Request for Class II Permissive Change

FCC ID: VG8XM048KYY

Please be notified that we, the undersigned, **Guangdong Midea Kitchen Appliances Manufacturing Co.,Ltd.** declare that the reasons for this class II permissive change are as below:

1. Changed Mother -board as below.

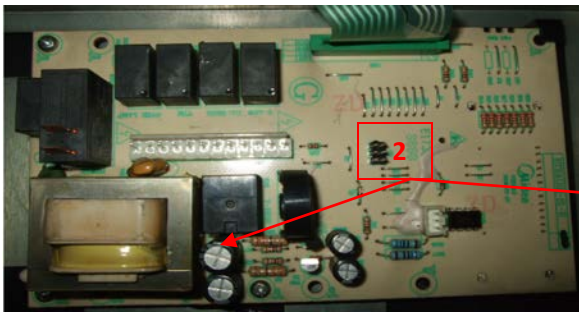
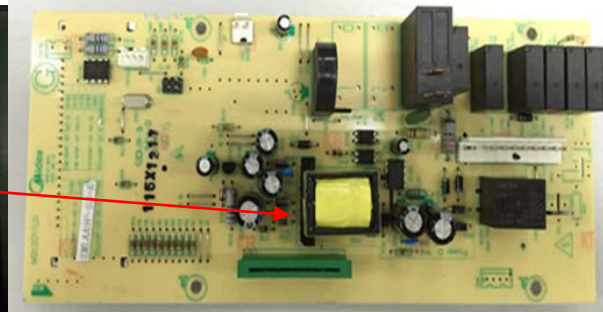
Note 1: They are the same Principle of circuitry only changed PCB Layout and location of circuit components.

Note 2: changed linear transformer to switching power supply.(see 2)

Original Mother board -bottom

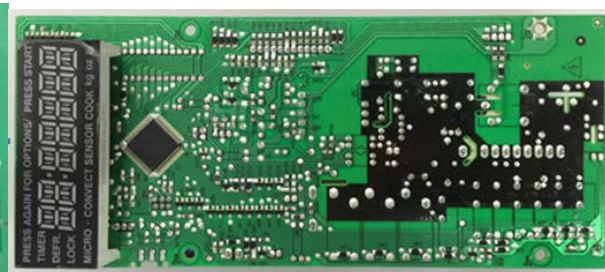
Only differences for LCD screen and PCB Layout. Anything elses are the same as before.
